Applicant: Joel THOMSON
Serial No.: 10/764,760
Filed: January 26, 2004
Page 8

Amendments to the Drawings

REMARKS

Figure 4

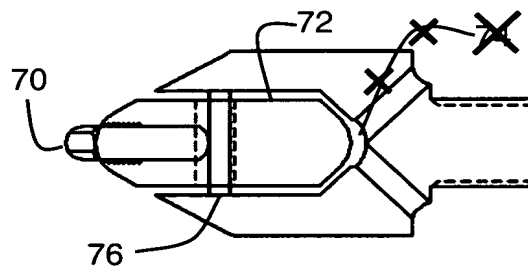
Section 5 of the Office Action objected to the drawings under 37 C.F.R. §1.84(p)(5) because the drawings include a reference character not mentioned in the description. More

specifically, the Office Action required corrected drawing sheets in which reference character "74" is removed from the figures.

Please replace the original drawing sheet "2/2" containing Figs. 3-5 with the Replacement Sheet attached as Exhibit A. The Replacement Sheet includes Fig. 4 in which reference number "74" and the corresponding lead line have been removed as shown in the Annotated Sheet Showing Changes accompanying the Replacement Sheet. Figs. 3 and 5 on the Replacement Sheet are unchanged from the original drawing sheet.

Applicant hereinabove has amended Fig. 4, the only figure which includes reference character "74", to remove both the reference character and the corresponding lead line. A Replacement Sheet with corrected Fig. 4 and unchanged Figs. 3 and 5 is attached as Exhibit A. An Annotated Sheet Showing Changes accompanies the Replacement Sheet in Exhibit A.
